Comments for Planning Application 23/01417/FULMAJ

Application Number: 23/01417/FULMAJ

Address: 1-8 Long Lane London EC1A 9HF

Proposal: Demolition of existing buildings to basement level and construction of a nine storey plus basement level building for hotel use (Class C1) with retail (Class E(a) / E(b)) use at part ground and basement levels together with ancillary cycle parking, associated servicing, plant, amenity terraces, landscaping and other associated works.

Table 1

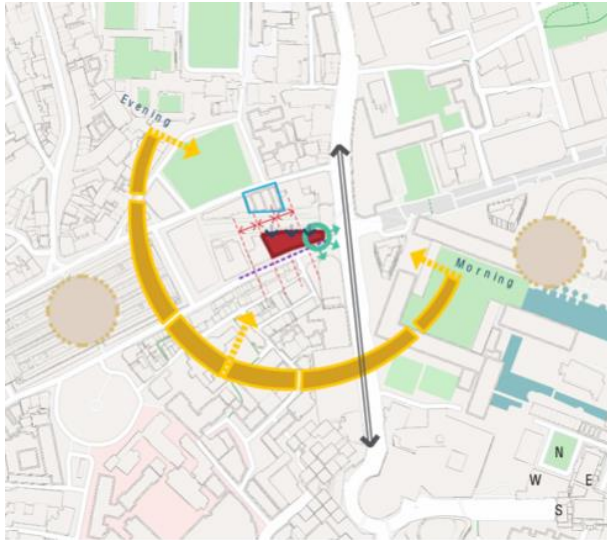
The below data shows that in most cases all the daylight and sunlight loss of the previously analysed scheme is taken by the current proposed scheme even though there is no allowance for the development of 9-12 Long Lane which would block considerable amounts of light in its own right. This is demonstrated by the below diagram from the Design & Access Assessment submitted in conjunction with **23/01417/FULMAJ** (section 2.8, p.20) (41-43 Charterhouse Square Highlighted in [light blue](#)). This shows that late morning and early afternoon sun strikes 31-43 Charterhouse Square though the footprint 9-12 Long Lane, emphasising the impact of the height and massing under proposal 23/01417, which alone causes as much impact as when 1-12 Long Lane were going to be developed to nearly the same height under 18/01020.

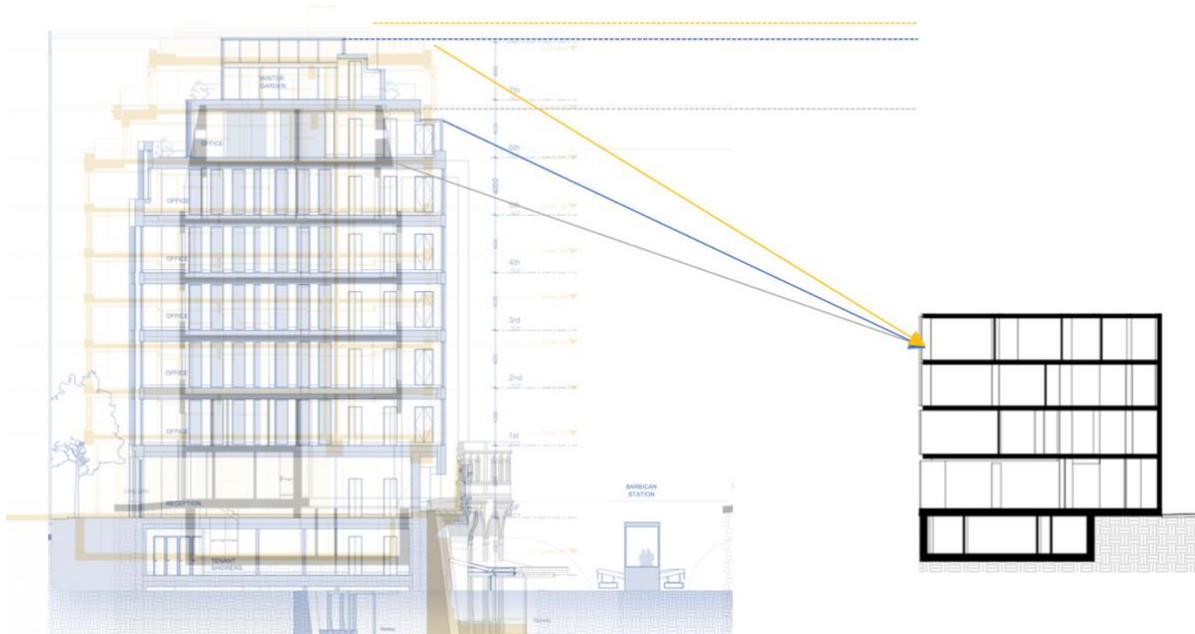
- v. It is very difficult to appreciate the impact of the massing on neighbouring buildings from the drawings and plans which have been provided in support of the application. It would be helpful to show an extended site cross-section, based on Sections A-A, B-B, and C-C (per below) which includes 42/43 Charterhouse Square and uses coloured lines to show the outline profile of (a) the existing building (b) the previously proposed schemes. These sectional drawings are missing from the publicly available files but must have been filed with the other application plans on 26th September, 2018, must have been debated, discussed and ultimately rejected and adapted in the eventually consented scheme from 18/01020. Comparison of the sectional drawings for the consented scheme and the the currently proposed scheme, is indeed essential so that the incremental massing impact of the set-back to floor 8 can be adequately considered by CoL Planning and all affected properties.

The below provides an illustration of the suggestion and also serves to demonstrate the extent of the height and massing issue from the perspective of the properties on the South side of Charterhouse Square (23/01417 impact shown in yellow and 18/01020) shown in light blue, with nearest point from 18/01020 in grey).

Heritage, Townscape and Visual Impact Assessment View 10

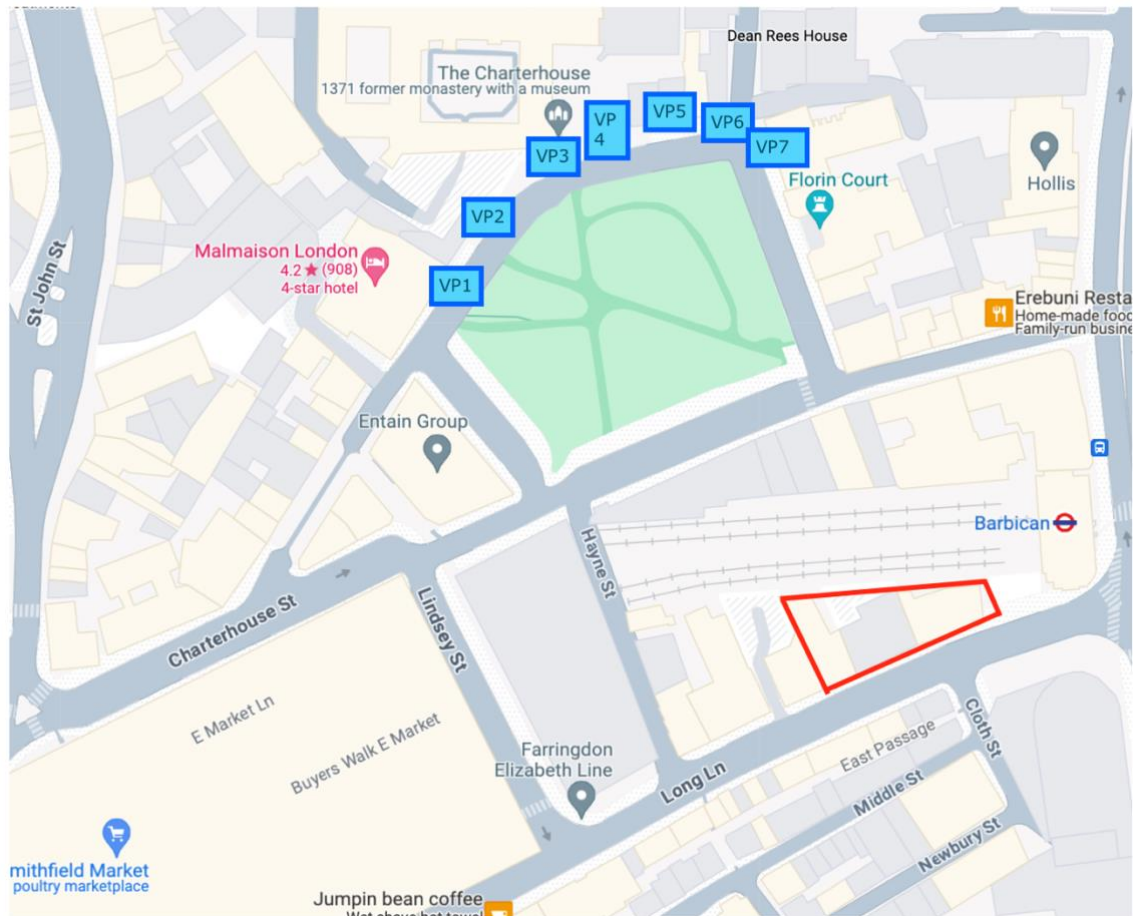
- vi. In addition, the claims in section 10.68 of this report are evidently false, as demonstrated by the above CGI.
 1. *10.68 The experience of the view is likely to be transient, while walking through the Square. Some receptors may sit in the garden in a similar viewing location, although this would be closer to the Proposed Development, where it would be more screened by interposing development.*

- vii. While viewpoint 10 has been selected to show a picture of lime trees in leaf in mid-summer, view point 11 has been selected to show that if a “receptor” is sufficiently far northwest within the private precincts of medical college grounds, it is difficult to see above the northern elevations of the Charterhouse. Neither view is representative of the impact of the development on the publicly accessible areas of Charterhouse Square.

Figure 9: Elevation to northern Side of the Railway Line

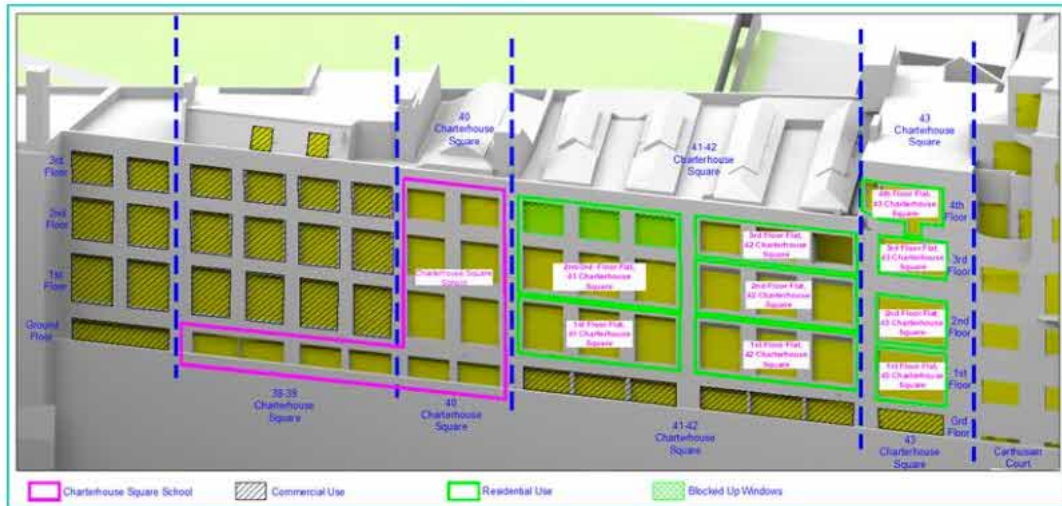
All the windows of all buildings from 33-40 Charterhouse Square should form part of any D&S Assessment, and not just those identified in 2018 and outlined in purple, as noted in a report dated 19th December, 2023.

The above is but one example of the omissions and inaccuracies which are evident in the report and stem directly from the submission of a report which purports to date from December, 2023 when the underlying work seems to have been carried out approximately five years previously.
